REMARKS

The drawings have been objected to for lack of appropriate reference numerals in Figs. 5, 7f, and 9d. The proposed drawing corrections are submitted herewith. Approval of the drawings is respectfully requested.

FIG. 7a

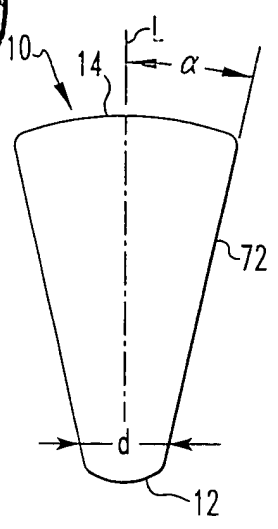
The specification is objected to for a typographical error in paragraph 37. This error has been corrected by amendment.

[0037] The rivet 10 shown in Fig. 10 is shown in detail in Fig. 7a. Rivet 10 includes slanted sides 72 which make an angle α with the centerline L of the rivet 10, with α being up to about 35°, preferably about 7° to about 25°. [On] One suitable diameter d of tip 12 of the rivet 10 is about 10 mm. Rivet 10 is shown as having a rounded tip, but the tip may also be planar. Other non-limiting examples of rivets are shown in Figs. 7b-7i. Rivet 80 shown in Fig. 7b includes a cylindrical portion 82 that steps down to a first slanted side 84 which makes an angle β with the centerline L of the rivet 80 and to a second slanted side 86 which forms an angle γ with the centerline L of the rivet 80, with β being greater than angle γ . As shown in Fig. 7c, rivet 90 includes an integral flange 92 and has a pointed tip 94. Rivet 100 shown in Fig. 7d is similar to rivet 10 except that rivet 100 has a tip 102 which defines a central opening 104. Another variation of rivet 10 is shown in Fig. 7e as rivet 110 which includes an integral flange 112 having sloping sides 114 and one or more helical groove(s) 116 defined in the surface. The helical grooves 116 assist in threading the rivet 110 into a work piece and act similar to a friction stir welding tool. Rivet 120 shown in Fig. 7f is similar to rivet 110 except that integral flange 122 has straight sides 124. A partially hollow rivet 130 (similar to rivet 80) with a tip 132 defining a cavity 134 is shown in Fig. 7g. Rivet 130 displaces less material and requires less axial force to plunge into work pieces. Alternatively, as shown in Figs. 7h and 7i, rivets 140 and 150 define respective bores 142 and 152 through the lengths thereof. Rivets having holes, cavities or bores typically deform during the friction plunge welding process yet may hide flash produced during riveting. For example, referring to Fig. 8, the tip 132 of the rivet 130 may deform such that the tip 132 is forced back in the opposite direction to the riveting direction and the cavity 134 widens to provide a mechanical lock in addition to the metallurgical bond produced during the riveting process.
